**GOVERNMENT OF THE DISTRICT OF COLUMBIA
DEPARTMENT OF TRANSPORTATION**

MEMORANDUM

SUBJECT: ZC Case No. 08-24C – Monroe Street Market Block E

Figure 1. Site Design and Access (Source: Transportation Memo, Gorove/Slade, Figure 2, December 22, 2017)

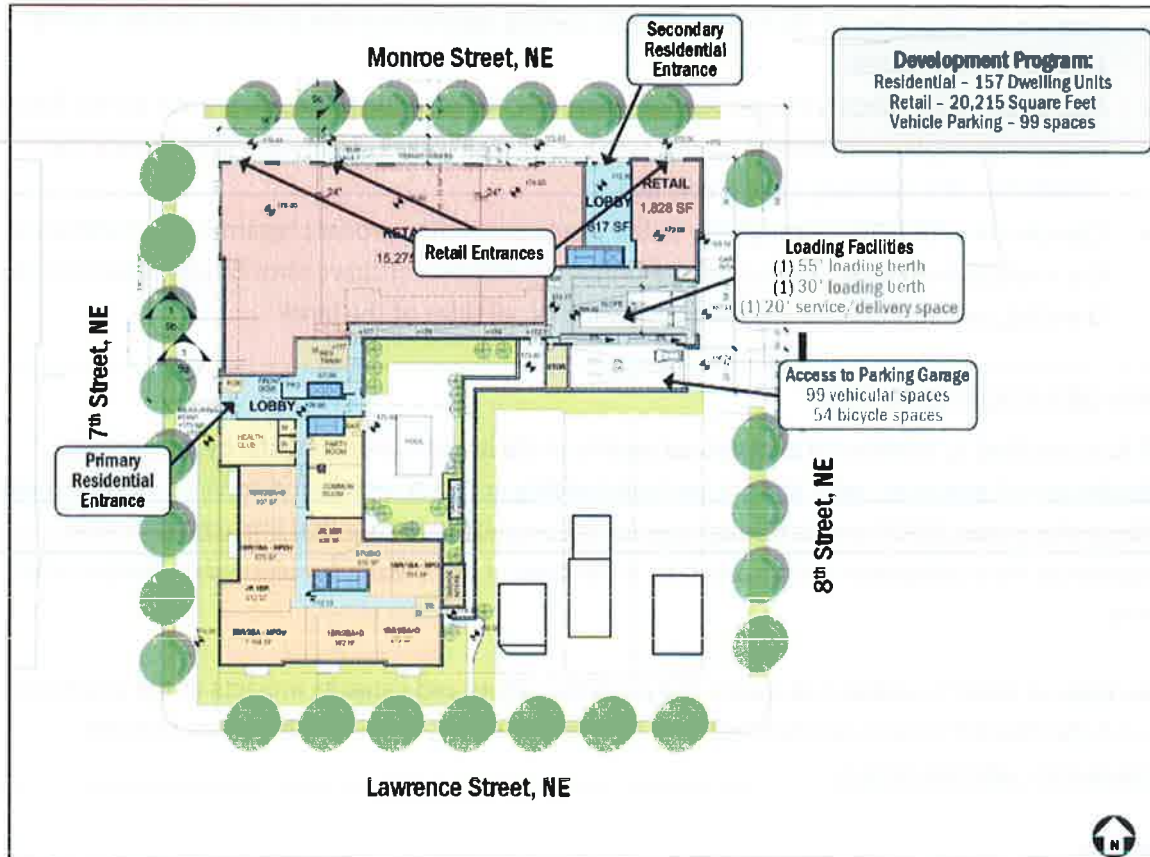
- DDOT concurs with the Applicant's proposed Loading Management Plan (LMP). Given the back-in loading design, and narrow width of 8th Street NE, which could be further narrowed if an on-street cycle track is ultimately installed on the east side, the Applicant should commit to provide a flagger to help facilitate ingress and egress of trucks (see Mitigations section below); and

The Applicant is not proposing to change vehicular and loading access from what was approved in ZC 08-24. The Applicant received Public Space Committee in April of 2011 for two curb cuts (loading and garage) on 8th Street NE, as shown in Figure 1. The proposed curb cut widths meet current DDOTs standards and the proposed separation is being updated with 12-feet of separation between the loading and garage access points.

- In addition to the presence of a dock manager, a flagger will be present whenever a vehicle is entering/exiting the loading dock. This flagger will alert pedestrian/bicyclists/other vehicles to trucks that may be entering or exiting the loading facilities; and
